**PLANNING DEPARTMENT TRANSMITTAL
TO THE CITY CLERK'S OFFICE**
SUPPLEMENTAL
CF 16-1411-S1

NOTES / INSTRUCTION(S):	
Supplemental Transmittal for existing Council File # 16-1411-S1 Transmittal of Staff Report to Planning and Land Use Management Committee, for Decertification of and Re-Certification of Environmental Impact Report (EIR), ENV-2012-920-EIR, including Partially Recirculated Final Environmental Impact Report (SCH number 2014061030) for the 4051 South Alameda Street Project This transmittal includes the Staff Report and five (5) associated attachments: • Attachment 1 - Notice of Completion and Availability of the Partially Recirculated Draft Environmental Impact Report • Attachment 2 - Notice of Completion and Availability of the Final Partially Recirculated Environmental Impact Report • Attachment 3 - Amended 2019 CEQA Findings • Attachment 4 - Gibson Transportation Consulting, Inc. Memo dated June 19, 2019 • Attachment 5 - January 8, 2019 Peremptory Writ of Mandate	
TRANSMITTED BY:	TRANSMITTAL DATE:

ENVIRONMENTAL CASE NO.:	ENV-2012-920-EIR
STATE CLEARINGHOUSE NO.:	2014061030
PROJECT NAME:	4051 South Alameda Street Project
PROJECT APPLICANT:	Pima Alameda Partners, LLC
PR

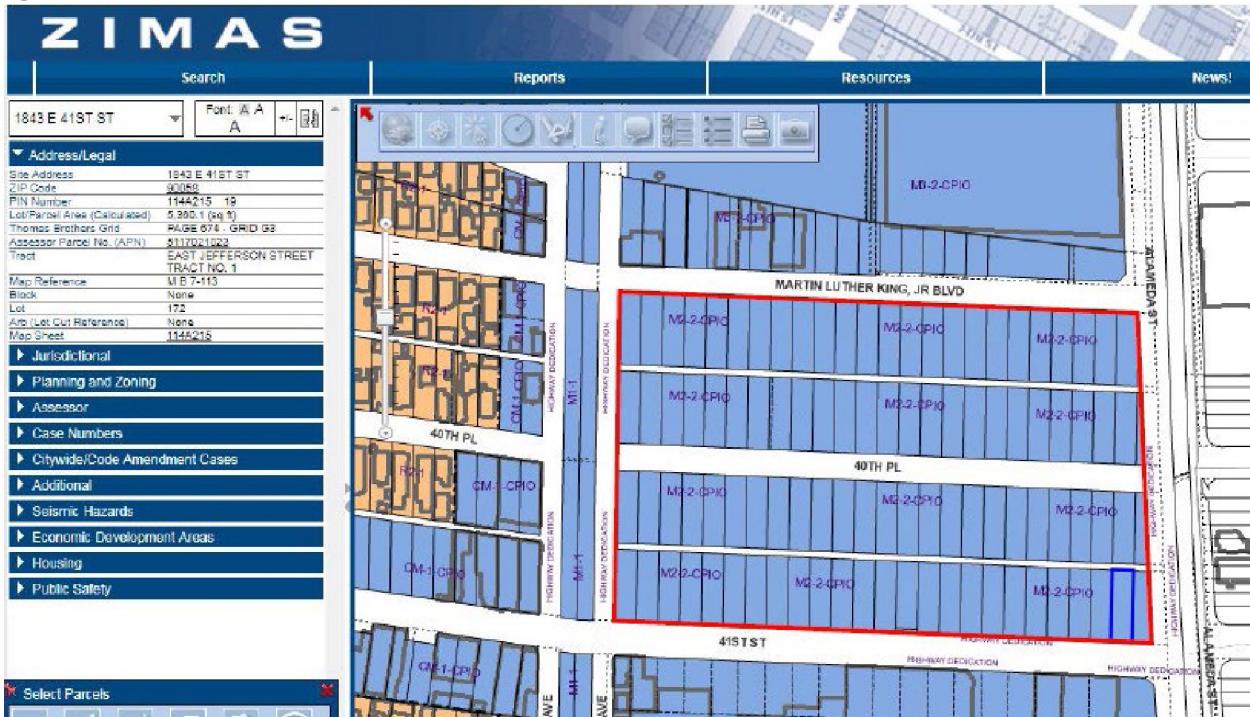
Warehouse	1843 East 41 st Street, Los Angeles, CA 90058
-----------	--

Response No. 8:

This same comment was responded to in **Response No. 11-7** of the PRFEIR. The project identified by the commentator as a warehouse located at 1843 East 41st Street, Los Angeles, CA 90058 appears to be located within the boundaries of the Project site. The Project site, which is currently vacant and free of any structures, is bounded by Martin Luther King Jr. Boulevard to the north, Alameda Street to the east, 41st Street to the south, and Long Beach Avenue to the west. According to the City Planning Department’s Zone Information and Map Access System (ZIMAS), the address provided by the commentator is located within these boundaries. See <http://zimas.lacity.org/>:

1843 East 41st Street, Los Angeles, CA 90058 was not included in the PRDEIR because operation of a warehouse at that address is mutually exclusive with the Project, and thus, would not produce impacts that would be cumulative with the Project. As such, 1843 East 41st Street would not meet the criteria for a related project. See CEQA Guidelines § 15130(b)(1)(a) (“past, present and probable projects producing related or cumulative impacts”).
